Access Compliance Report Public Rights-of-Way (Curb Ramps)

Main Street: OMEGA_DR Cross Street: BROWNING_AVE Location: SW

ADA ID: RPRK211014115454 Ramp Type: Type 7 - Directional 2 Initial Pass/Fail: Fail Overall Compliance: No Severity Score: 2

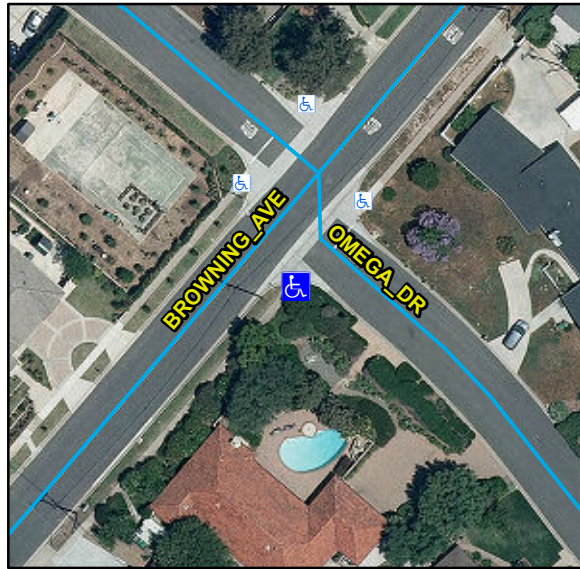
Compliance	Description	Data	Compliance	Description	Data
N/A	Ramp Length (in)	169	N/A	Flare Type LT	
Yes	Ramp Width (in)	48			N/A
Yes	Ramp Run Slope (%)	7	N/A	Flare Slope LT (%)	N/A
No	Ramp Cross Slope (%)	2.3	N/A	Flare Traversable LT	N/A
N/A	Grade Break	N/A	N/A	Flare Type RT	
N/A	Grade Break Slope (%)	N/A			N/A
N/A	Grade Break Cross Slope (%)	N/A	N/A	Flare Slope RT (%)	N/A
	Addl Para Ramp Left?	No	N/A	Flare Traversable RT	N/A
	Addl Para Ramp Right?	No	N/A	DWS Provided	N/A
N/A	Landing Present	N/A	N/A	DWS Contrast	N/A
N/A	Landing Length (in)	N/A	N/A	DWS Length (in)	N/A
N/A	Landing Width (in)	N/A	N/A	DWS Full Width	N/A
N/A	Landing Run Slope (%)	N/A		DWS Offset Type	N/A
N/A	Landing Cross Slope (%)	N/A	N/A	DWS Left Offset (in)	N/A
N/A	Landing Movement Obstructed?	N/A	N/A	DWS Right Offset (in)	N/A
	Landing Movement Type	N/A			
N/A	Landing Shared	N/A			
N/A	Marked Crosswalk 1	No	N/A	Clear Space	N/A
	Crossing 1 Direction	NE	N/A	Clear Space To Crosswalk (in)	N/A

Marked Crosswalk 1 Width (in)	N/A			
N/A	Ramp Inside Crosswalk 1	N/A			
	Crossing 1 Slope (%)	4.3			
	Crossing 1 Cross Slope (%)	2.9			
N/A	Gutter Ponding	N/A	N/A	Curb Slope	10.8
Yes	Gutter Lip Height (in)	0		Road Run Slope (%)	N/A
N/A	Gutter Run Slope (%)	N/A		Road Cross Slope (%)	N/A
N/A	Gutter Cross Slope (%)	N/A		Parallel Ramp Side	Left
Yes	Overall Surface Condition	Acceptable	Yes	Perp Joint Present	Yes
	Cross Gutter Present?	Yes		Spandrel Present?	Yes
	Replace Cross Gutter?	No		Replace Spandrel?	No

Remove & Replace Entire Ramp.

R304.5.3, STD 1115
